# UNITED STATES PATENT AND TRADEMARK OFFICE

APPLICATION NO.	FILING DATE	FIRST NAMED INVENTOR	ATTORNEY DOCKET NO.	CONFIRMATION NO.
09/913,977	08/20/2001	Stephen Proulx	MCA-449 PC/US	8230
29621	7590	12/23/2003	EXAMINER	
MYKROLIS CORPORATION 129 CONCORD ROAD BILLERICA, MA 01821-4600			POPOVICS, ROBERT J	
			ART UNIT	PAPER NUMBER

<b>Office Action Summary</b>	<b>Application No.</b> 09/913,977	<b>Applicant(s)</b> PROULX ET AL.	
	<b>Examiner</b> Robert J. Popovics	<b>Art Unit</b> 1724

## DETAILED ACTION

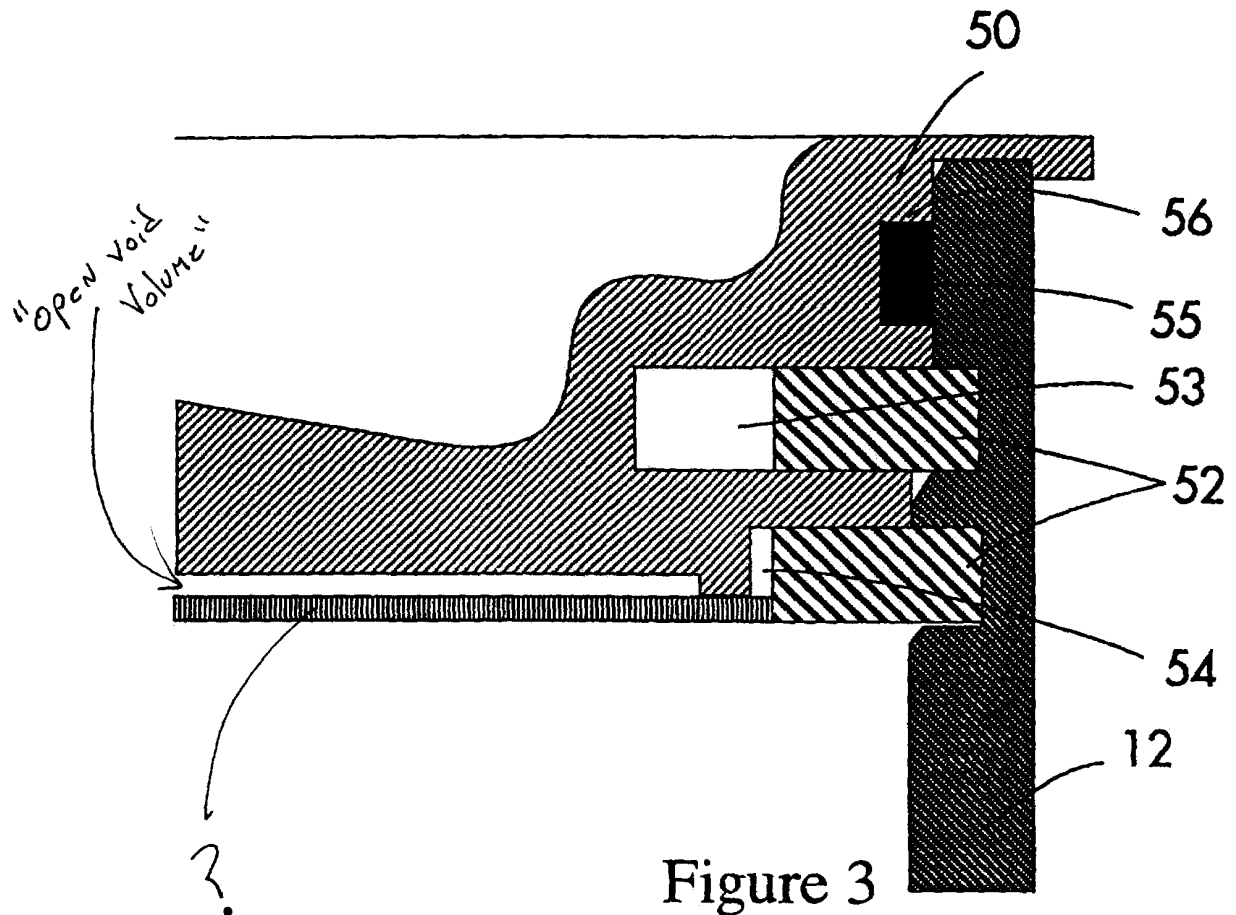
Claims **1-9** and **15-17** are rejected under 35 U.S.C. 112, first paragraph, as failing to comply with the enablement requirement. The claim(s) contains subject matter which was not described in the specification in such a way as to enable one skilled in the art to which it pertains, or with which it is most nearly connected, to make and/or use the invention. Below is Fig. 3 (the elected end cap species) taken from Applicant's specification.

**Figure 3** appears to have an “open void volume” as indicated by the handwritten arrow, yet Applicant’s “single generic concept is the provision of a depth filter free of an open void volume upstream of the depth filter in order to remove undesirably large particles from the filter being filtered.” Since an open void volume appears to be clearly shown in the drawing, the disclosure is not commensurate with the scope of the claims, and does not enable one skilled in the art to practice the invention. Moreover, it is unclear what the unlabeled member beneath the open void volume, is (see arrow with question mark).

It is unclear what Applicant intends by the recitation **“being free of an open void volume upstream of the depth filter.”** The elected end cap species (Fig. 3) appears to show an open void volume upstream of the depth filter (see the enablement rejection above). Thus, it is unclear what Applicant means by this language in the context used. Furthermore, the “inlet” and the “outlet” appear to constitute “open void volumes.” It is unclear if Applicant’s claims intend to exclude these volumes from the “hollow housing” volume. As drafted, the claims are seen to include the open void volumes of the inlet and outlet, and thus, present an inconsistency in the claim language. It is unclear where Applicant intends the “hollow housing” volume to end, and the inlet and outlet volumes to begin. As drafted, the meaning of the claims is unclear, since the housing has an inlet, which appears to constitute “an open void volume,” when the claim specifically precludes an open void volume from being upstream of the depth filter.
